RED/GREEN 5/22

PRELIMINARY PLAN

SR 5 JOB NO. 7412 SHEET 1 OF 3

C.S. 3401 ~ PROJ. NO. OL3451D ~ OLYMPIC REGION ~ I-5 ~ GRAND MOUND I/C TO MAYTOWN I/C ~ PRAIRIE CREEK BRIDGE NO. 5/302E REPL.

PLAN

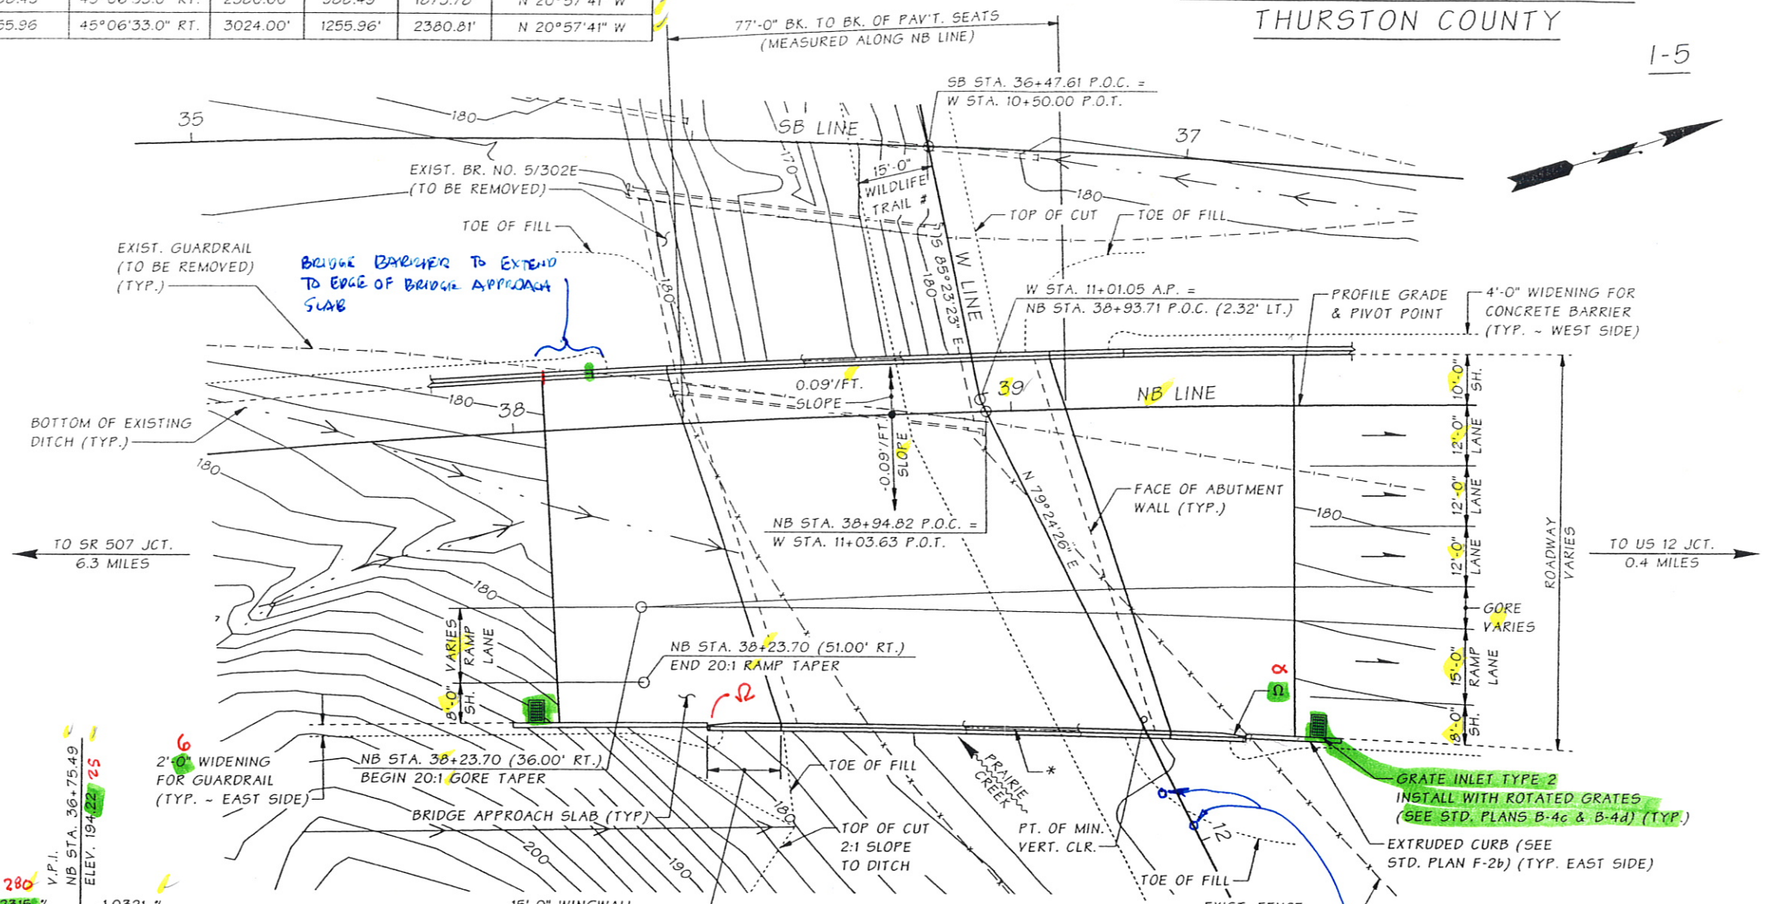
(THRIE BM NOT NECESSARY ON DOWNSTREAM ENDS, SO CONNECT W-BEAM GR TO BRIDGE BARRIER DIRECTLY WITH AN "F" CONNECTION.)

BRIDGE EMBANKMENTS WILL FOLLOW THE FORMAT GIVEN IN STANDARD PLAN C-25.20-00, WHETHER GR IS USED OR NOT. EMBANKMENT WIDENING IS MEASURED 3' OUTSIDE OF BRIDGE BARRIER, ASSUMING 2' FOR BRIDGE BARRIER FOR A TOTAL OF 5' EMBANKMENT WIDENING. STD. PLAN H-9 SHOWS THE EMBANKMENT WIDENING AS BEING MEASURED FROM THE OUTSIDE OF THE BRIDGE BARRIER
